ADDENDUM #4

07/24/2014

**TO PLANS AND SPECIFICATIONS FOR
RENOVATION AND ADDITION TO
FT. SAM HOUSTON ELEMENTARY SCHOOL
&
RENOVATION AT COLE HIGH SCHOOL**
Ft. Sam Houston
San Antonio, TX

SHEET TITLE:
**TYPICAL FOUNDATION
DETAILS**

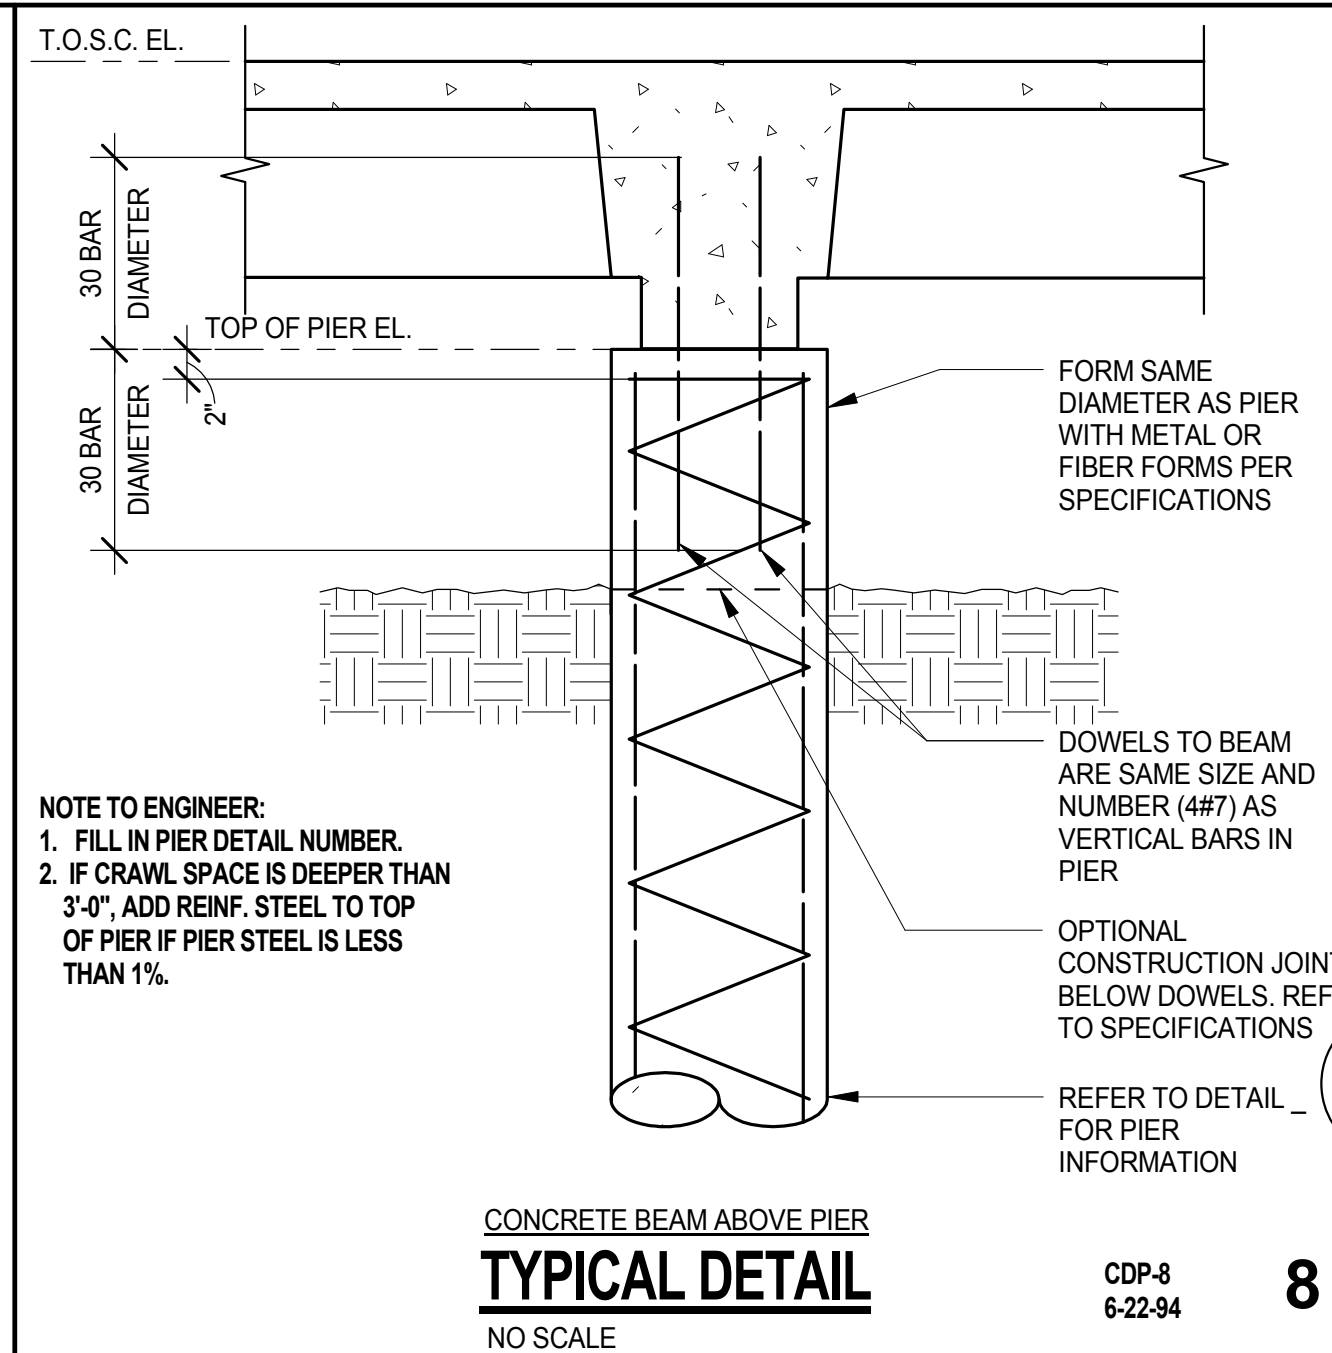
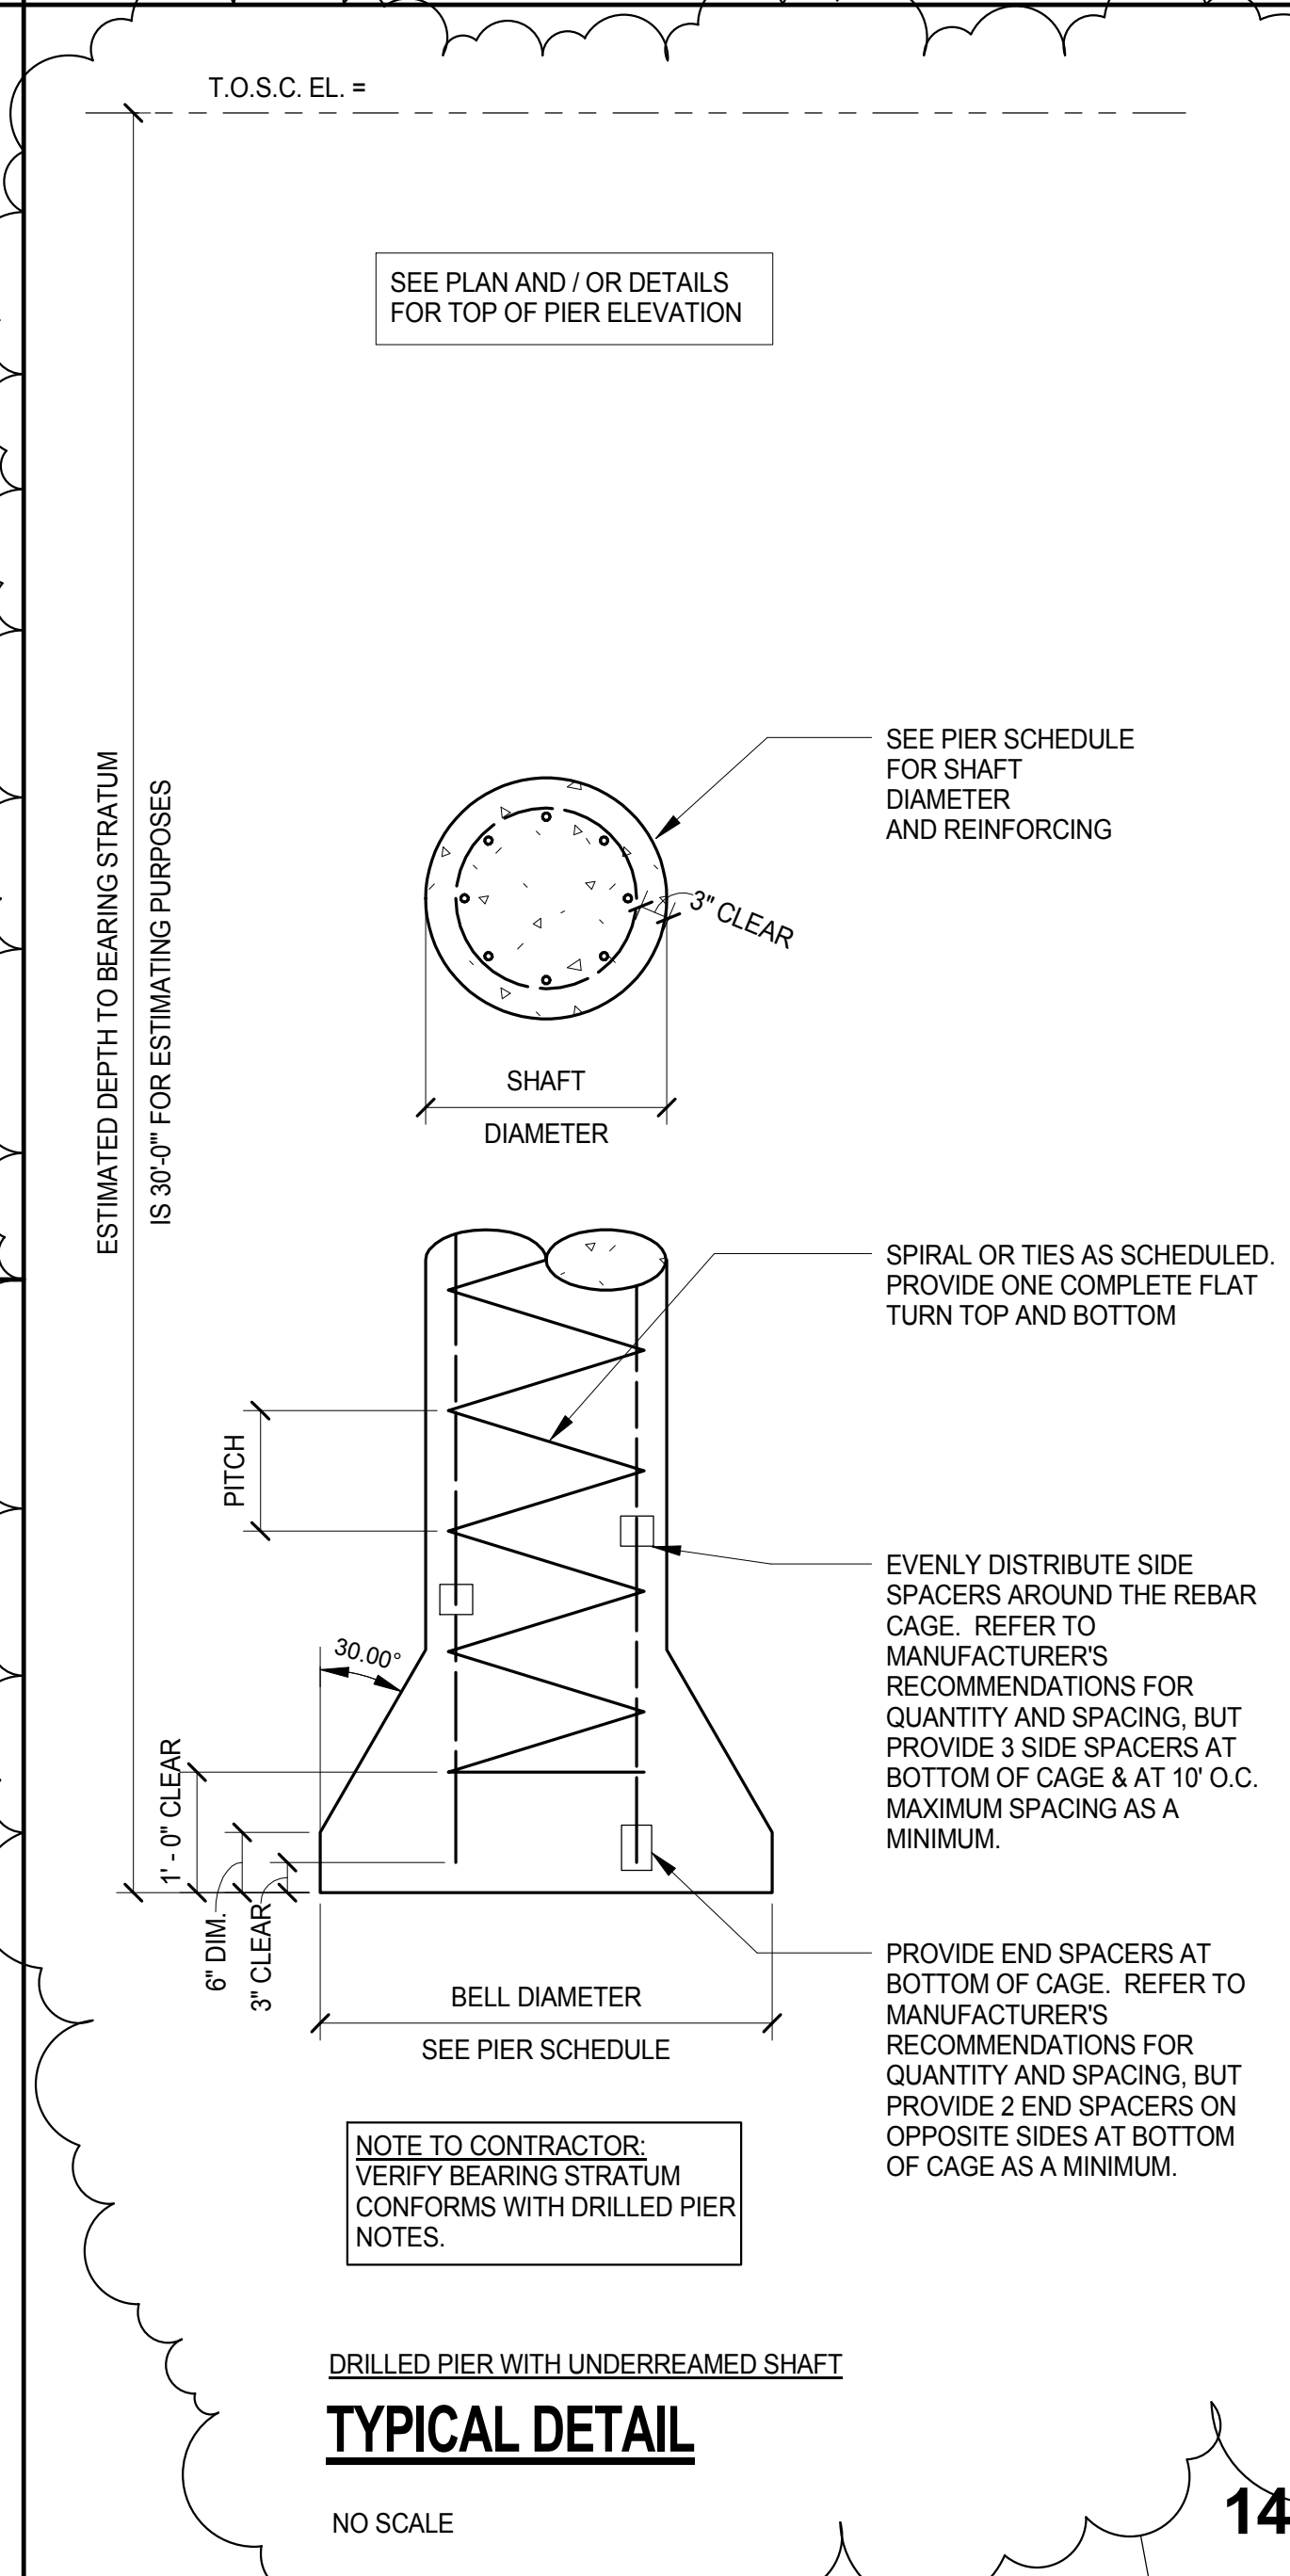
- A. Sheet S300:
 - a. See revised sheet for changes to typical pier detail and pier schedule.
- B. Sheet S310
 - a. See revised sheet for clarifications to grade beam reinforcing.
